ADDENDUM

Project: <u>lona South Heritage 09TSC</u>	Project No.: <u>500599017010101</u>	Addendum No.: One
Project Address: 4440 E High Grove Rd., Idaho Falls, ID 834	<u>01</u>	Date: <u>April 19, 2017</u>

From (Architect): NBW Architects Idaho Falls, Idaho

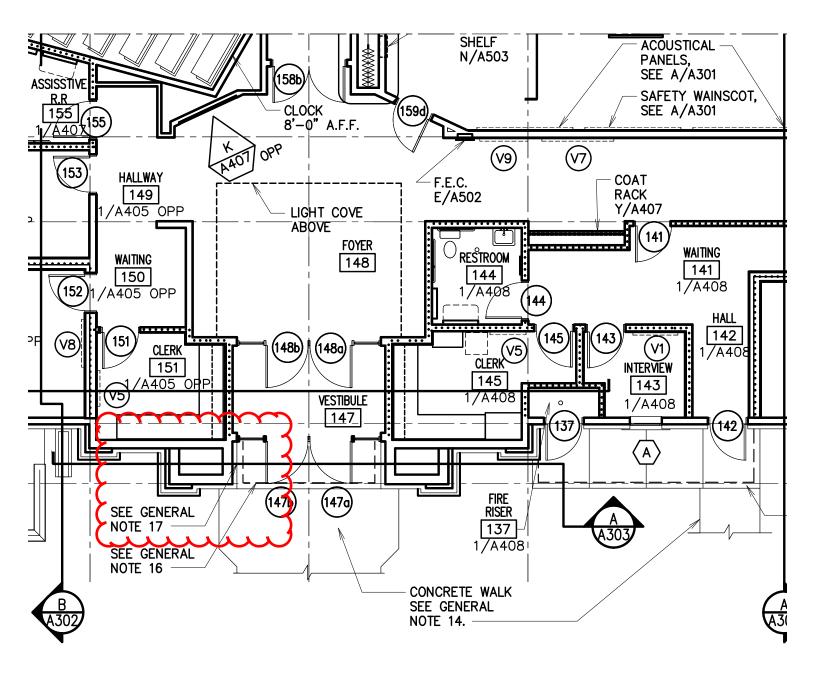
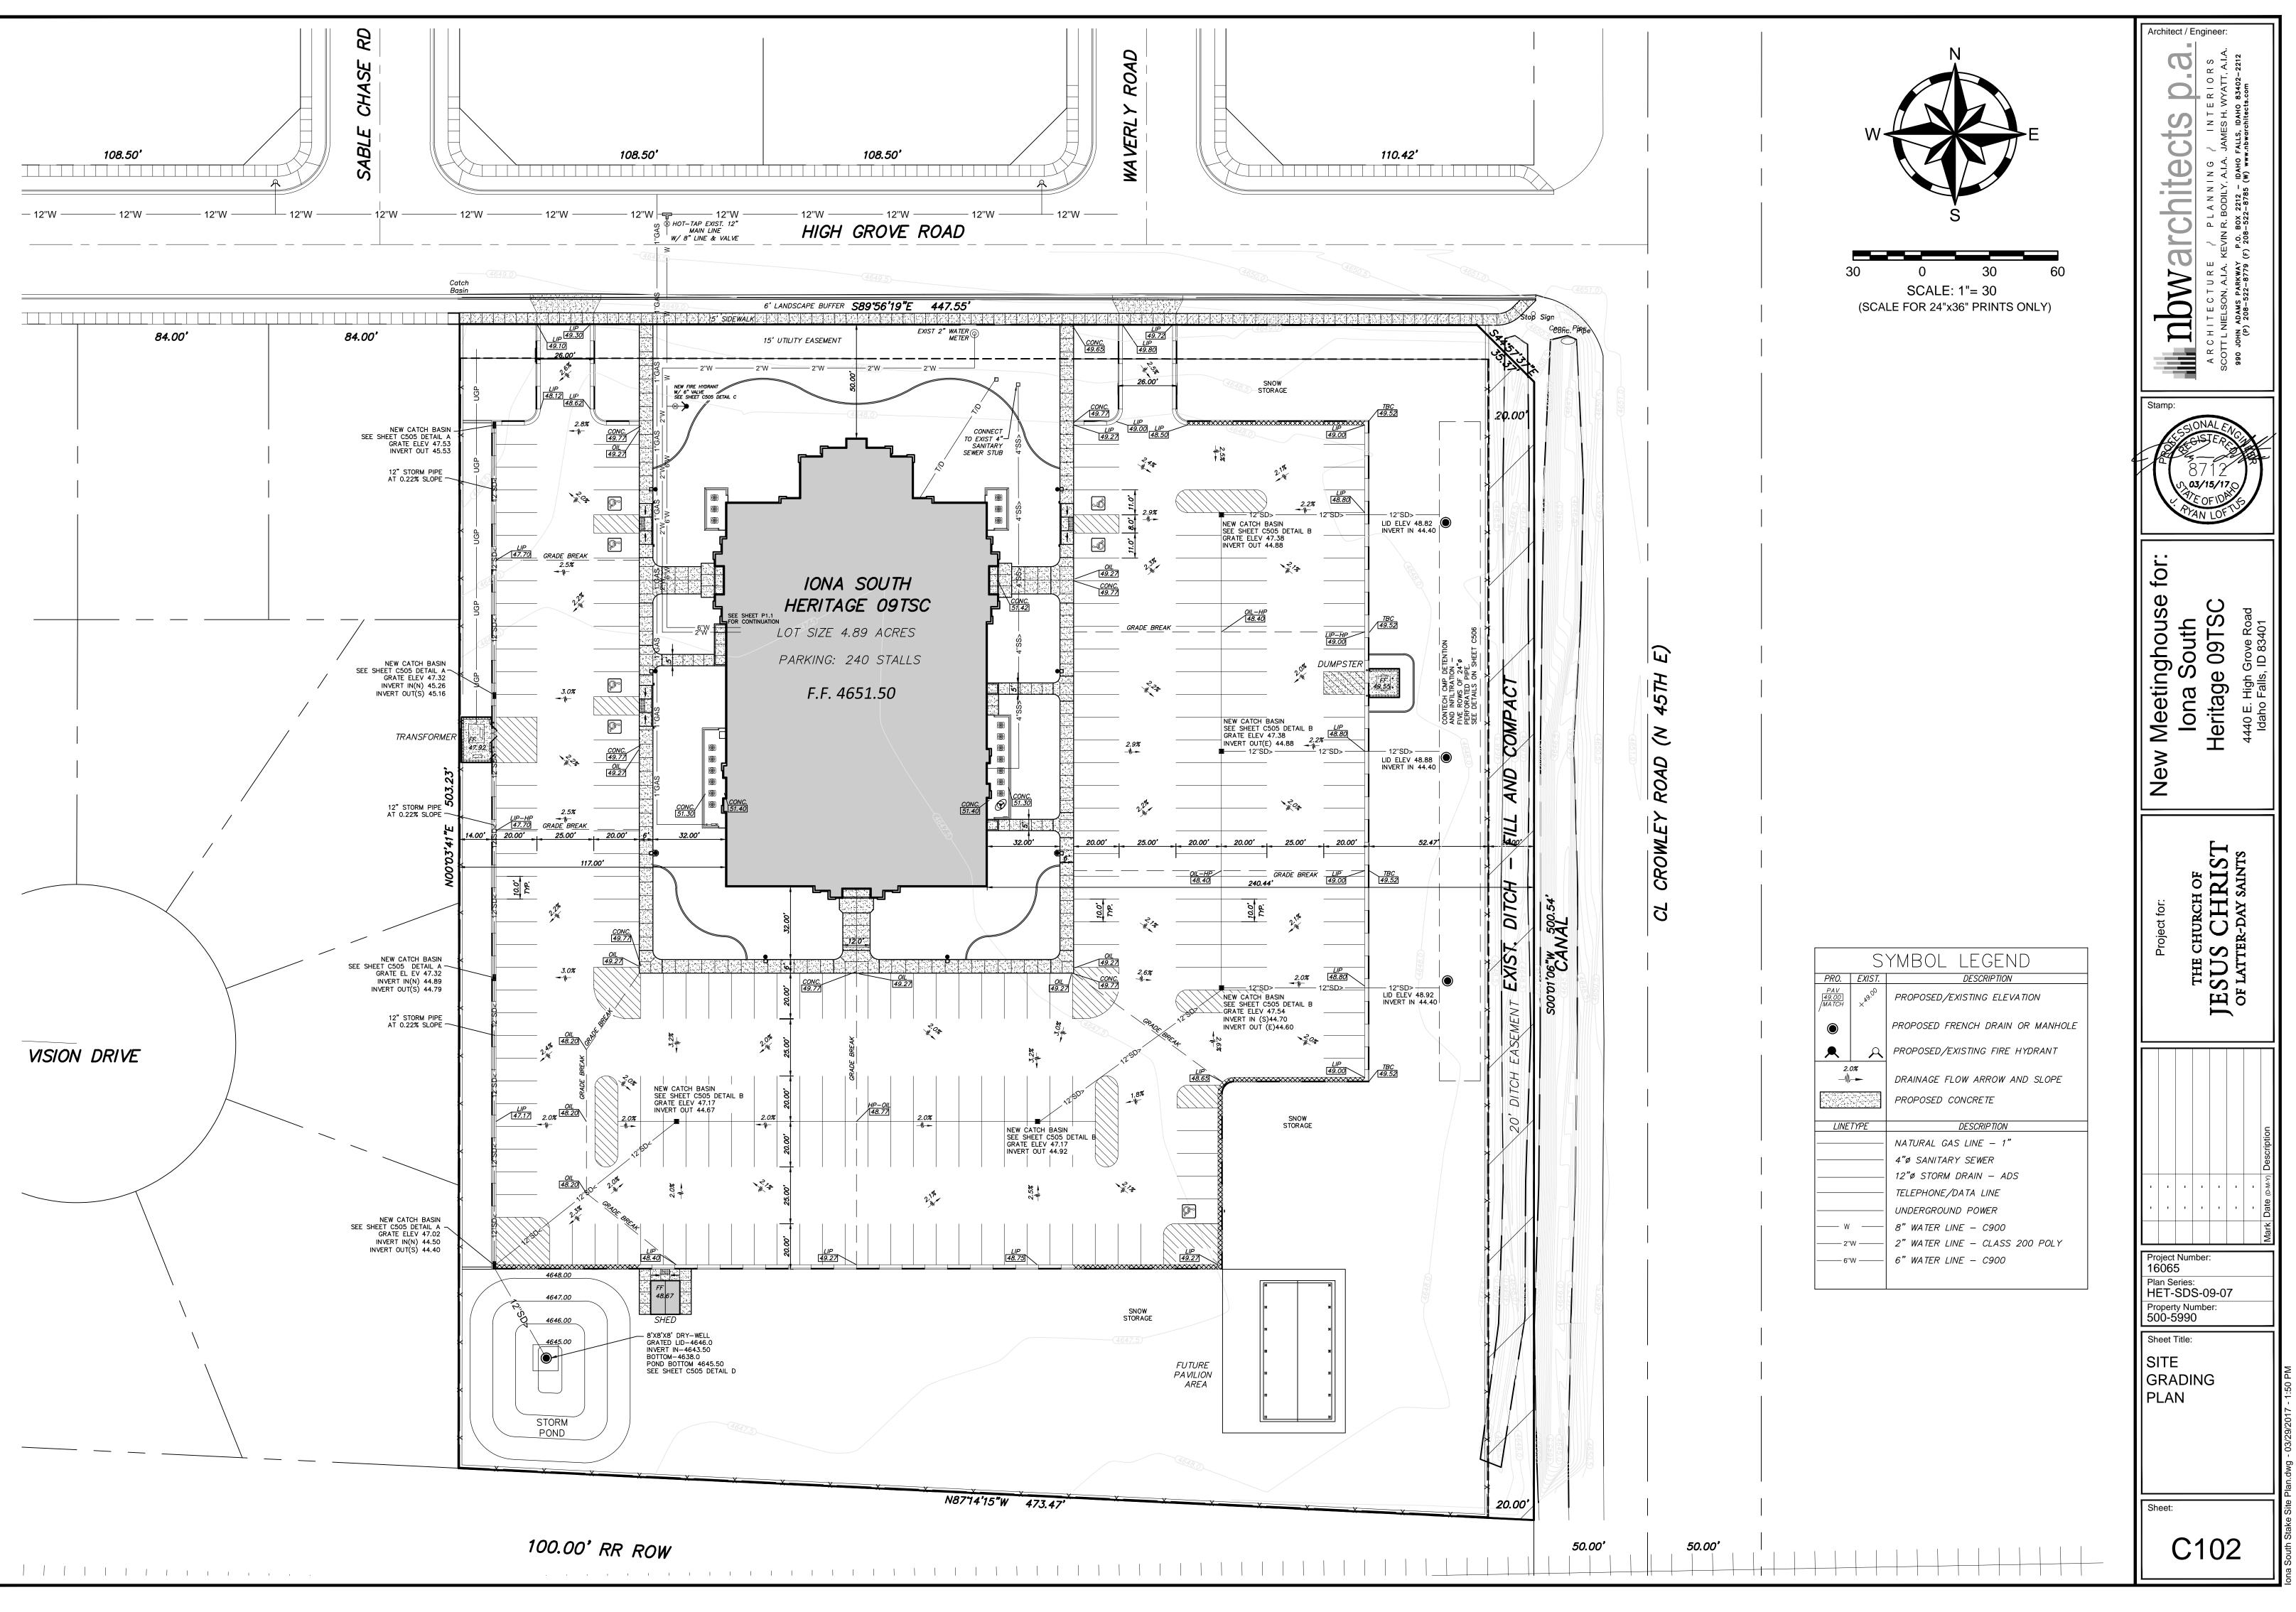
1. Sheet S511, Detail N. Remove weld symbol from detail. Beam and column are wood products.

Iona South Heritage 09TSC NBW Architects "Knox: Box Location AD1.1

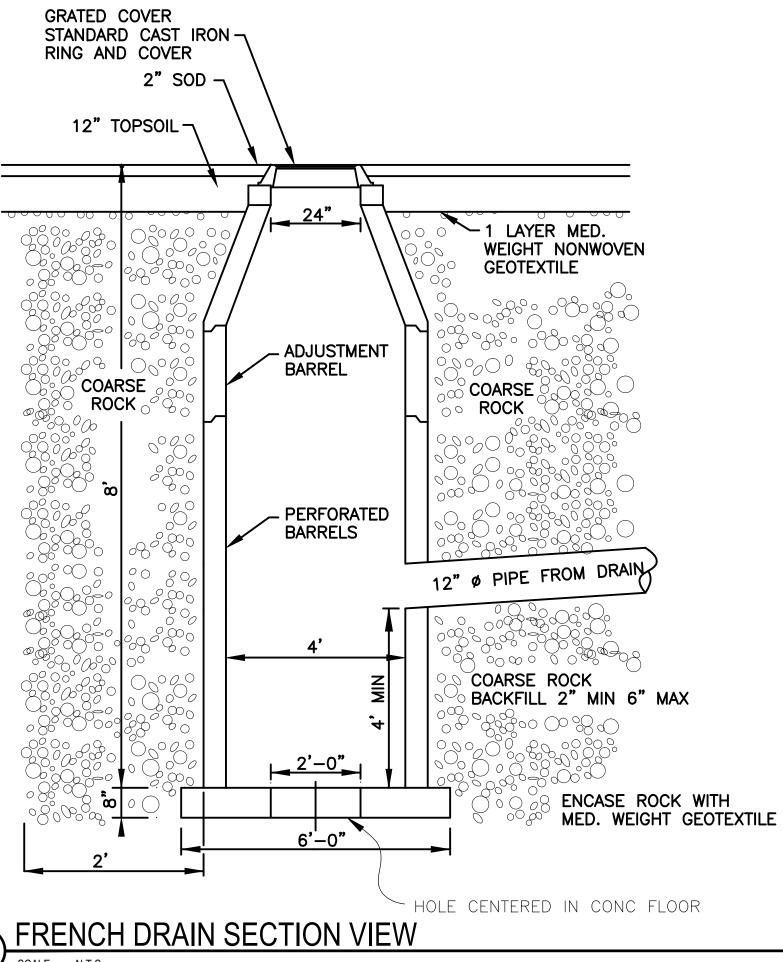
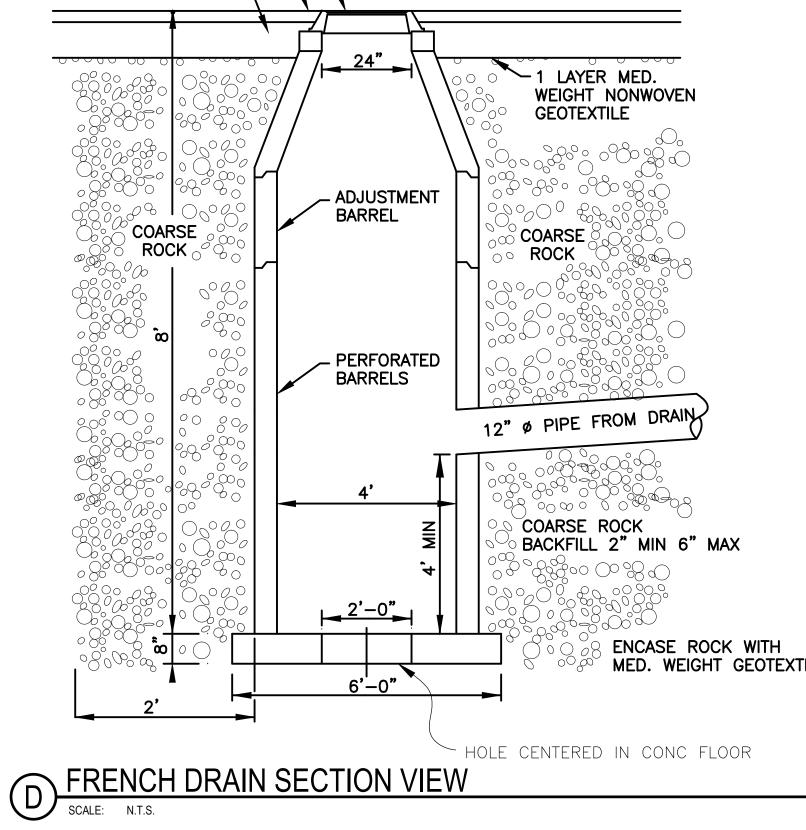
- 1. Sheet A101, General Note 17. "Knox Box" to be installed in wall north of Door 147b. See attached Sketch AD1.1.
- 2. Sheet A201, Elevation 2. Note designating "EIFS LINTEL" above window Type B should read "PRE-CAST CONCRETE LINTEL".
- 3. Sheet A407, Detail P, Typical Accessory Mounting Location. The toilet paper dispenser when installed in ADA compliant toilets should be centered 7-9 inches in front of the toilet.
- 4. Sheet A603, Window Types. Window Type C to have clear glazing.
